Docket No. 52-021
MHI Ref: UAP-HF-09453

Subject: **Amended MHI's Responses to NRC's Requests for Additional Information on Advanced Accumulator for US-APWR Topical Report MUAP-07001-P, Revision 2**

Amended MHI's Responses to NRC's Requests for Additional Information

Advanced Accumulator for US-APWR Topical Report MUAP-07001-P, Revision 2

Fig. 33-1 Example of Distension of a Nitrogen Bubble due to Gas Expansion

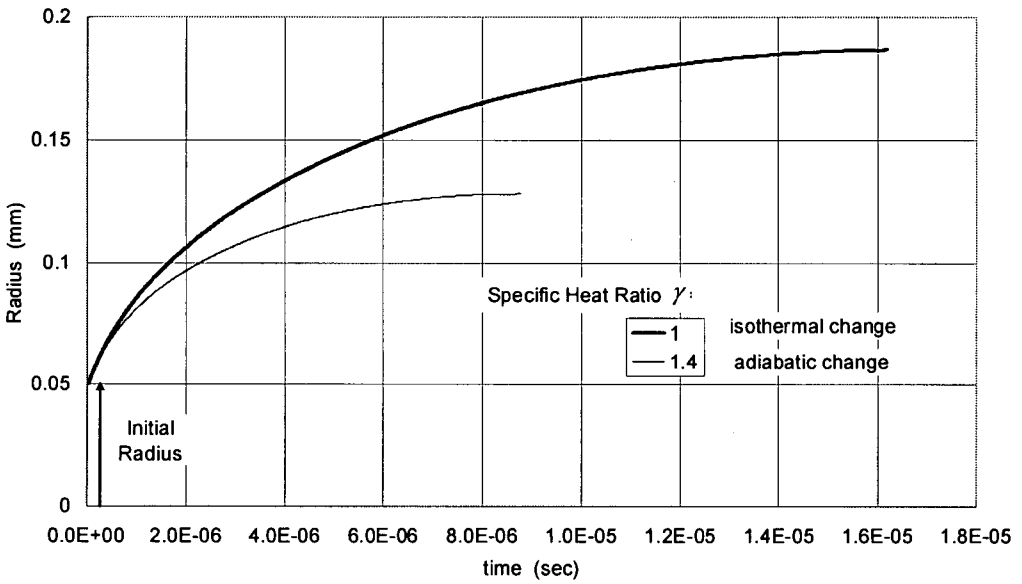
RAI 33.
It will take time for accumulator to become saturated with nitrogen. The upper layer will saturate but thereafter, the dissolved gas will diffuse to the rest of the accumulator liquid. If there are any convection currents in the liquid, the mixing will be even faster. The response to RAI 5b dated September 2008, regarding the dissolved ratio of nitrogen in terms of diffusion period of 2 years through 10 years, does provide the actual concentration of the dissolved gas, and the dissolution of the gas as the fluid particles move to the lower pressure. The amount of gas that will evolve depends on the nucleation sites and interfacial area.

Why are the effects of nucleation sites, interfacial area density and convection not addressed, in addition to the diffusion process?

About nucleation sites and interfacial area density:
Numerous cavitation nuclei are generally contained in water. There are also some cavitation nuclei on the walls of the vortex chamber and the throat. The size of nuclei seems to be in the order of 10^{-3}inch in water.
The pressure drop in the actual accumulator tank is slow. However, let's consider a nitrogen bubble that experiences abrupt depression from the storage pressure of 5.33MPa to an atmospheric pressure of 0.101MPa at time t=0 sec as a stepwise to be able to examine the growth of the bubble as the most conservative. The bubble at first rapidly expands due to gas expansion, then nitrogen slowly permeates in water due to diffusion of saturated nitrogen. Bubble dynamics due to gas expansion in inviscid fluid is given by the following equation (L.D. Landau and E.M. Lifshitz: Fluid Mechanics, Pergamon Press, 1975):

Where R is radius of the bubble, $P(t)$ pressure on the surface of the bubble, t time, ρ density of fluid, and p_0 ambient pressure.
The distension of a spherical bubble with an initial radius 2×10^{-3}in (0.05mm) due to gas expansion is shown in Figure 33-1. Surface tension on the bubble was taken into account in the calculation. Bubble distension due to gas expansion is very rapid. For adiabatic change, or

specific heat ratio γ=1.4, the bubble is distended in $9x10^{-6}$ sec, and for isothermal change, or γ=1.0, the bubble is distended in $1.6x10^{-5}$ sec. An actual bubble will be abruptly distended in time between them.

Figure 34-1 Accumulator flow rate during Large Break LOCA

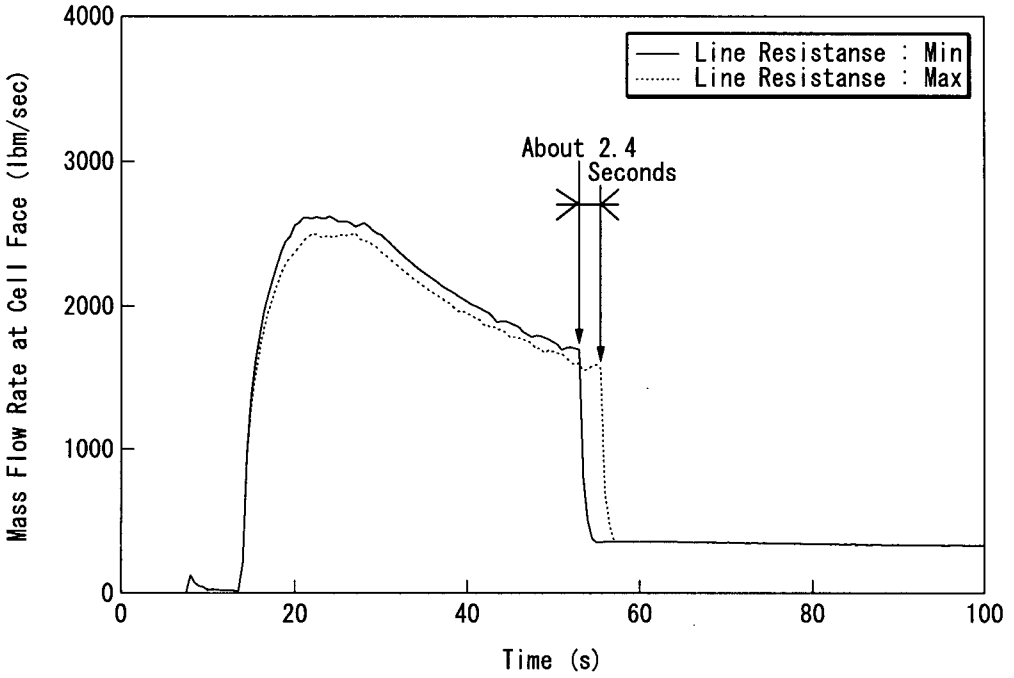
(c)
How is the effect of nitrogen accounted for in implementing accumulator characteristic equations? Is there any delay in accumulator flow to account for nitrogen effect? How is this delay estimated? How is this delay validated to full scale accumulator?

(c) In Large Break LOCA analysis, the accumulator injection line piping resistance uncertainty is treated as a statistical parameter, and the resistance which is sampled randomly from uniform distribution within the range of $\pm 10\%$ is used for the analysis. For the cases with maximum and minimum piping resistance, duration of large flow injection period is different by approximately 2.4 seconds (Figure 34-1). Therefore, the large flow injection completion time delay induced by the effect of nitrogen is bounded by considering piping resistance uncertainty.

As above description, 2.4 seconds of large flow injection completion time delay considering piping resistance uncertainty encompasses 2 seconds of delay in full height 1/2 scale test case 5. The large flow injection completion time delay in test case 5 is expected to be applicable to full-scale accumulator for the following reasons:

- Since the Full-height 1/2 scale model is used in the actual pressure condition, time axis of injection characteristic (time vs. injection flow rate) is the same in the test model and actual accumulator. Therefore, with the initial tank pressure and back pressure equivalent to the actual condition, the injection time of test and actual accumulator will be the same.

- The large flow injection completion time delay in test case 5 is assumed to be induced by expansion of microbubbles formed by compulsory bubbling and showering before the test initiation by depressurization, which decreased effective density of water and increased pressure drop in the flow damper and injection pipe. Since bubbles grow very fast according to pressure change as described in the response to RAI 33, decrease of effective density of water does not depend on the scale of accumulator tank and flow damper if the amount of microbubbles in the tank water and tank pressure are the same. It is very conservative to consider large flow injection completion time delay which is comparable with the delay time in the test case 5 as the worst case in safety evaluation because the initial pressure of test case 5 is equal to the pressure in the actual ECCS performance analysis, and microbubbles more than test case 5 do not exist in the actual accumulator since compulsory bubbling and showering is not conducted.
